**MONTGOMERY COUNTY HISTORIC PRESERVATION COMMISSION**  
**STAFF REPORT**

<b>Address:</b>	7209 MacArthur Blvd., Bethesda	<b>Meeting Date:</b>	12/7/2022
<b>Resource:</b>	Contributing Resource <b>Potomac Overlook Historic District</b>	<b>Report Date:</b>	11/30/2022
<b>Applicant:</b>	Kim & Arthur Newmyer (Robert Black, Architect)	<b>Public Notice:</b>	11/23/2022
<b>Review:</b>	HAWP	<b>Staff:</b>	Dan Bruechert
<b>Permit No.:</b>	1008960	<b>Tax Credit:</b>	Partial
<b>Proposal:</b>	Partial demolition and construction of a new rear addition, hardscape alteration, and fenestration alterations.

## Response to Historic Preservation Commission Preliminary Consultation Report

Re: 7209 MacArthur Blvd, Bethesda, MD

1 BUILDING SECTION  
A300 3/8"=1'-0"

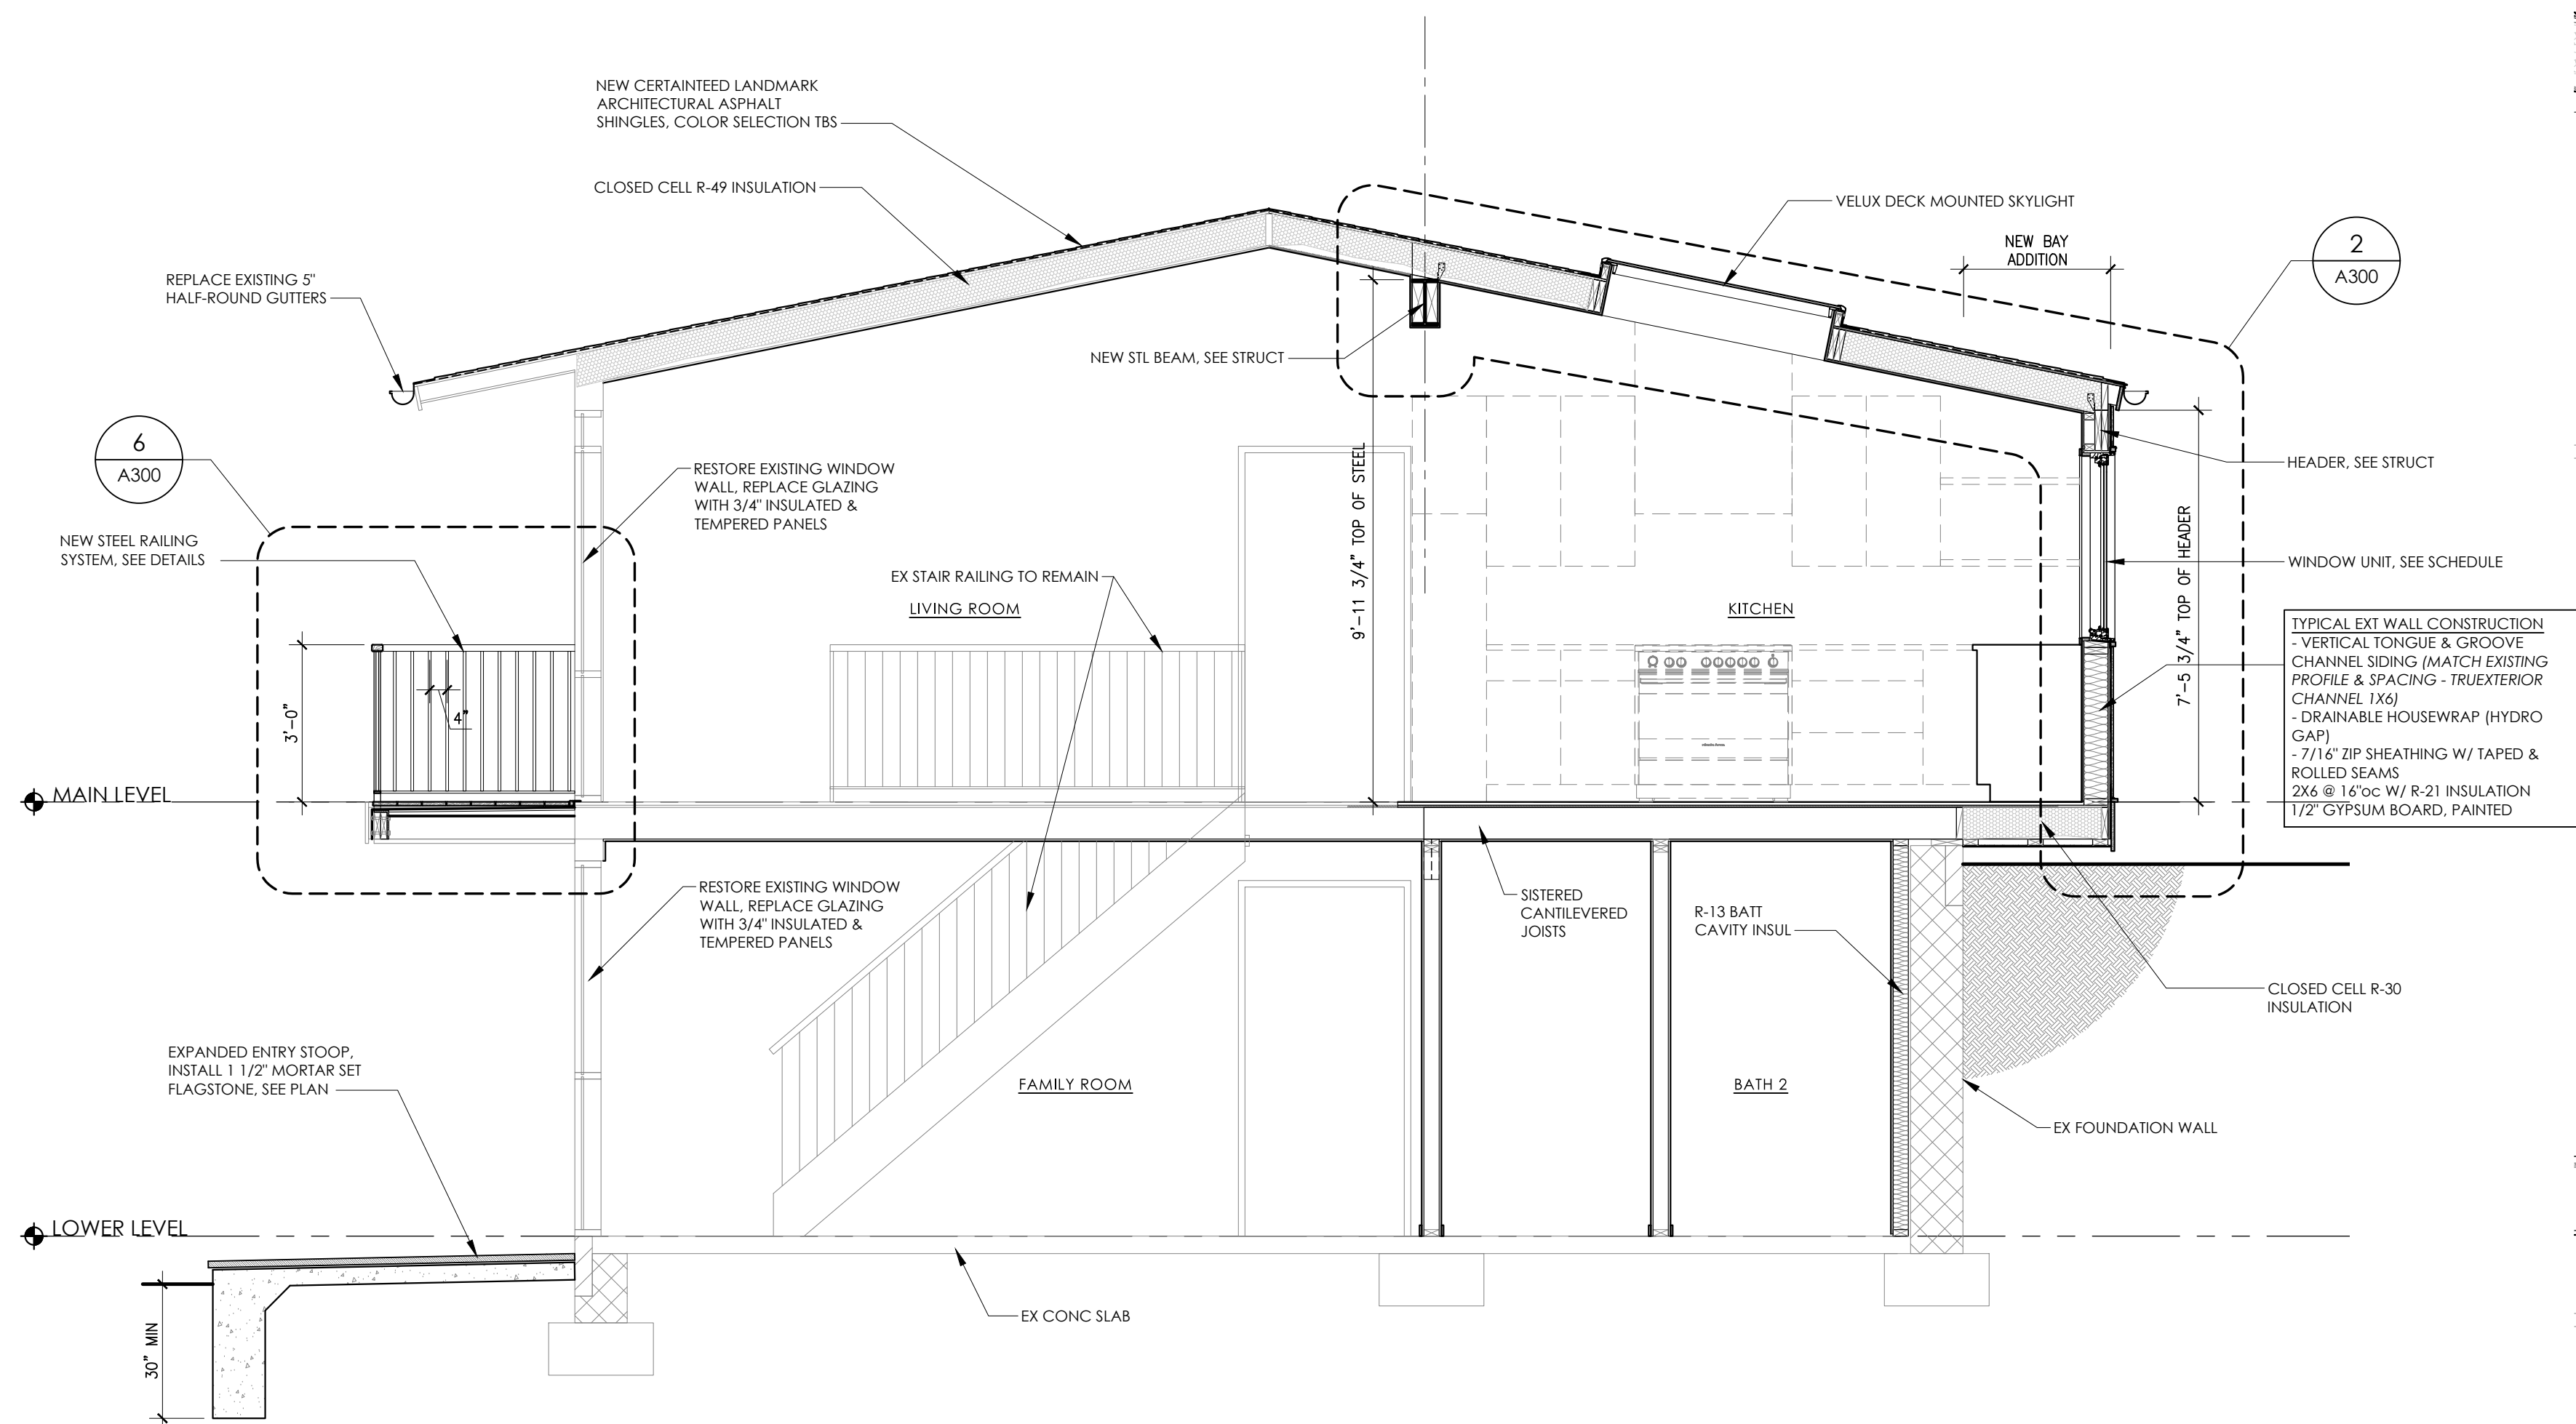
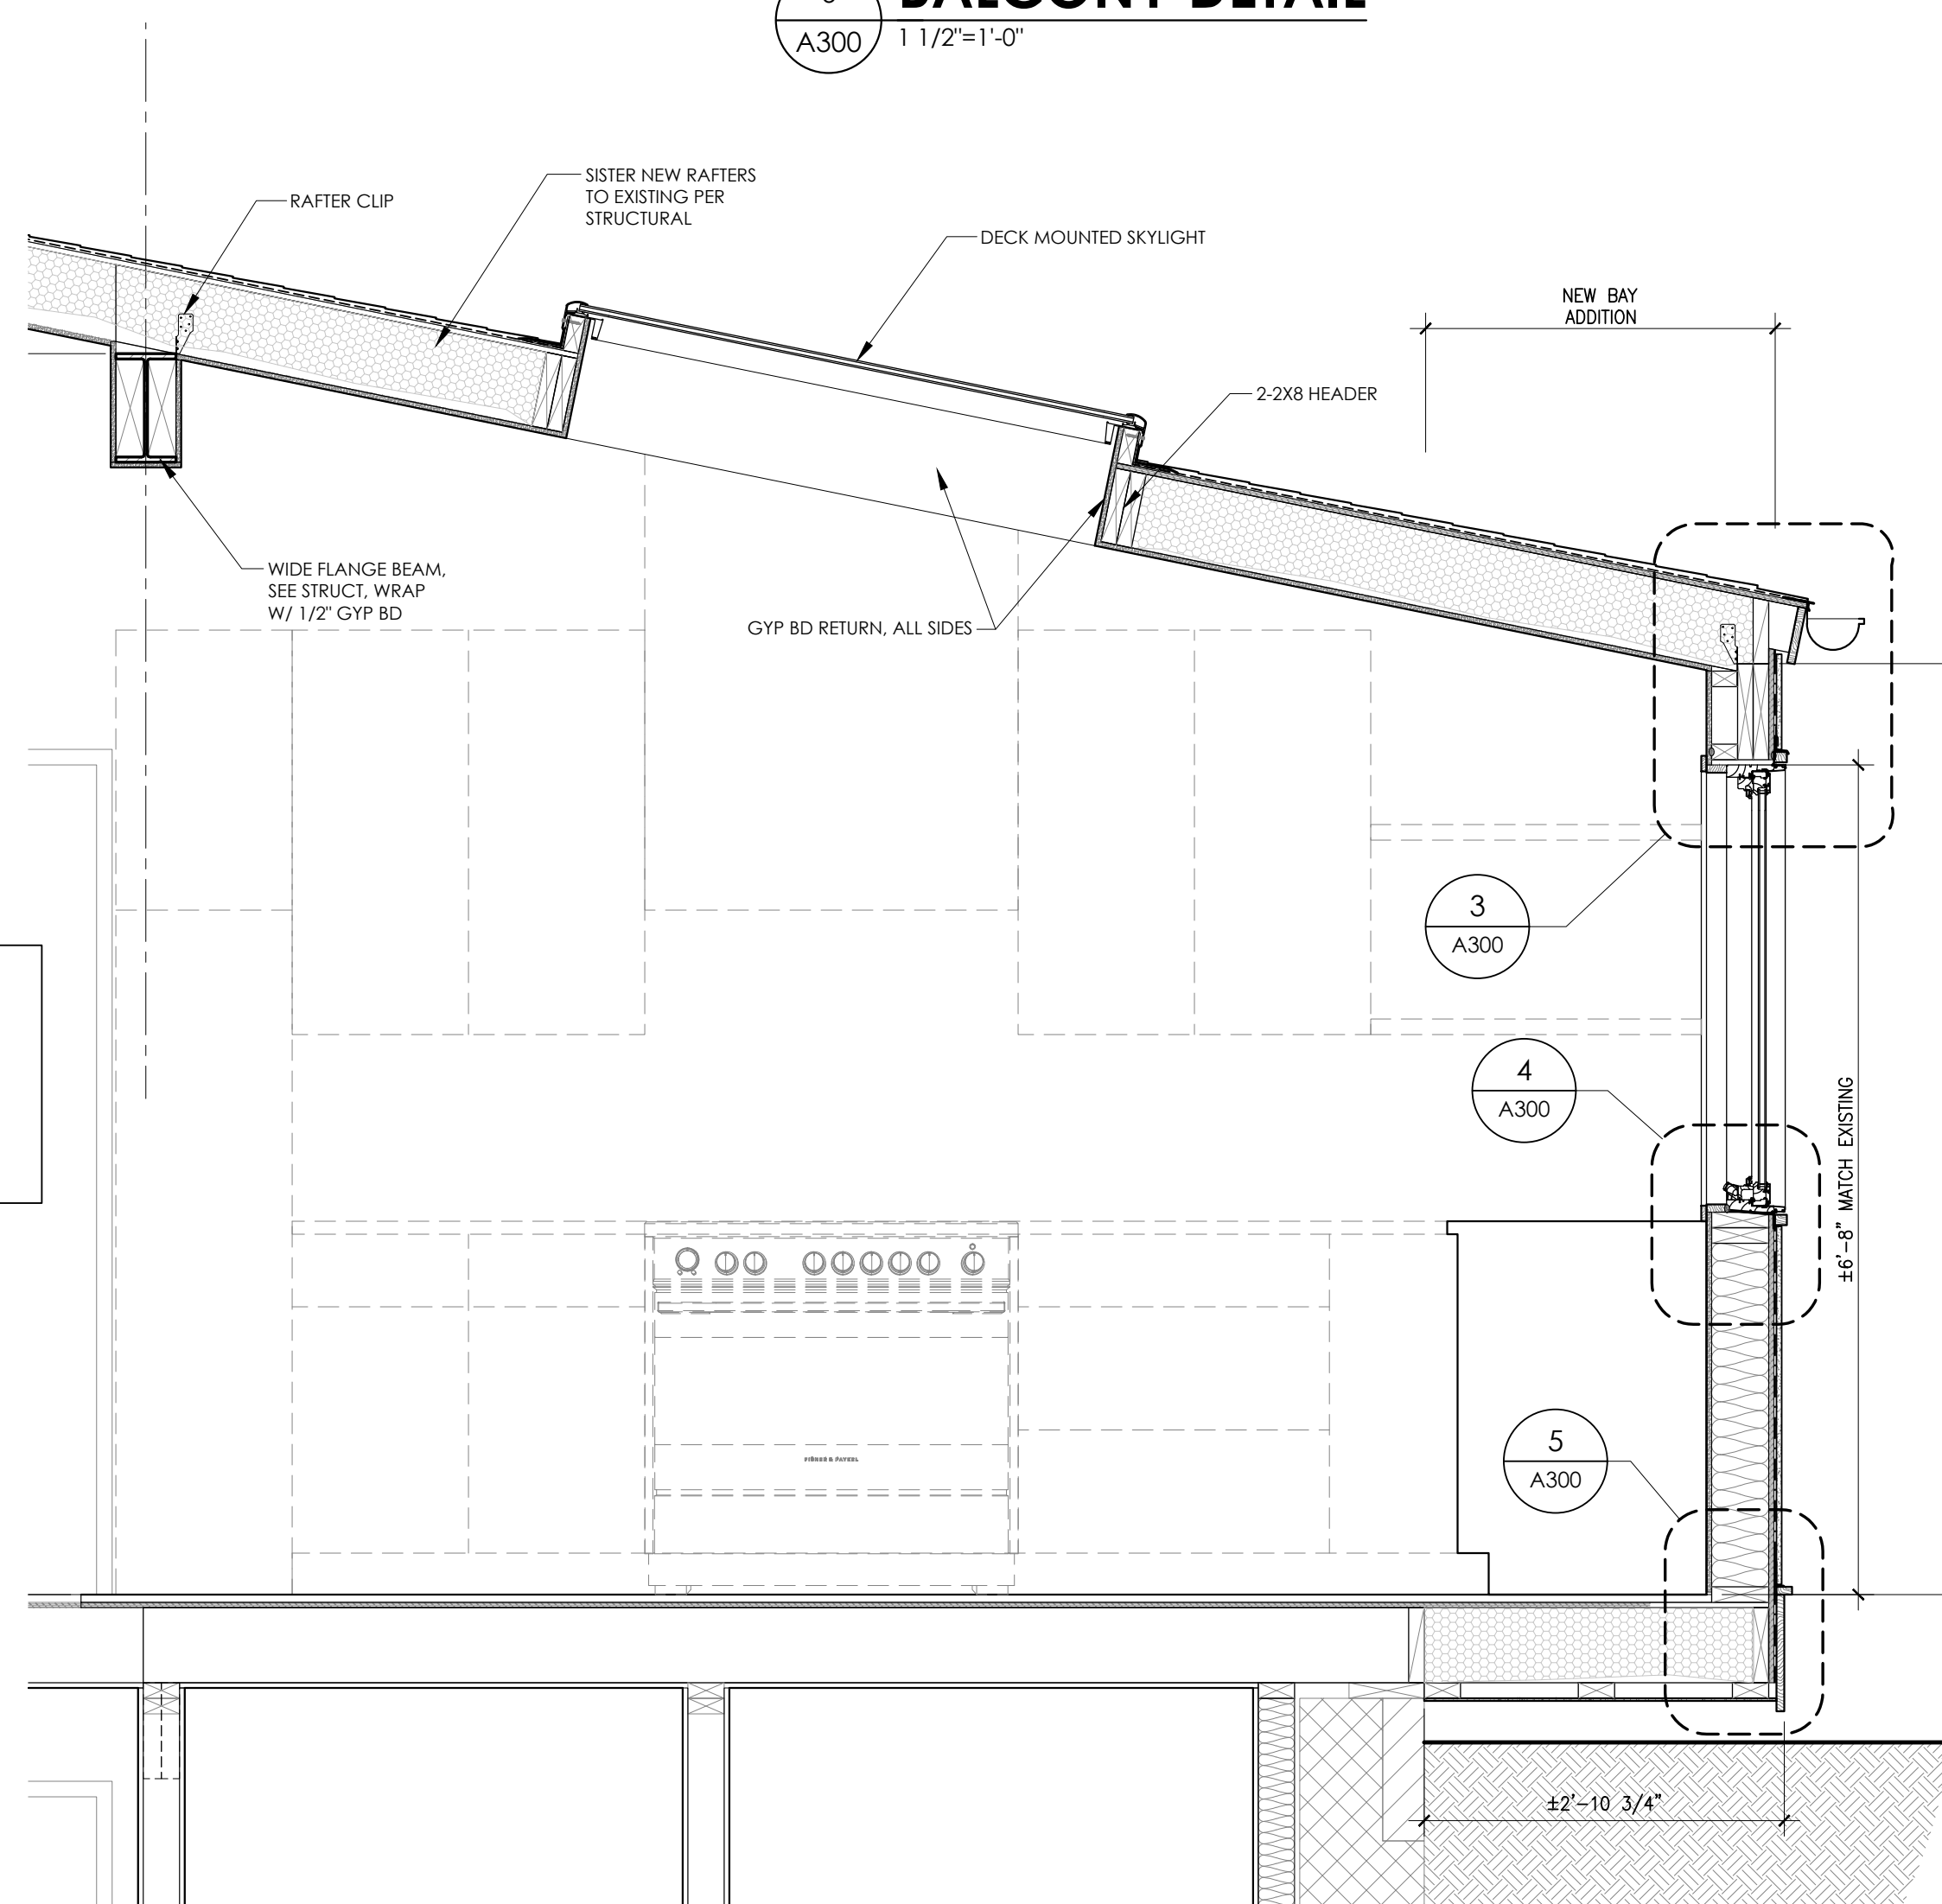
- **Comment:** *Windows must be appropriately detailed – window specifications need to be included in the HAWP application.*

**Response:** All proposed window and door trim will match the existing profile using painted wood. See details on drawing A200, wall details on A300 and A800 for sections of window units.
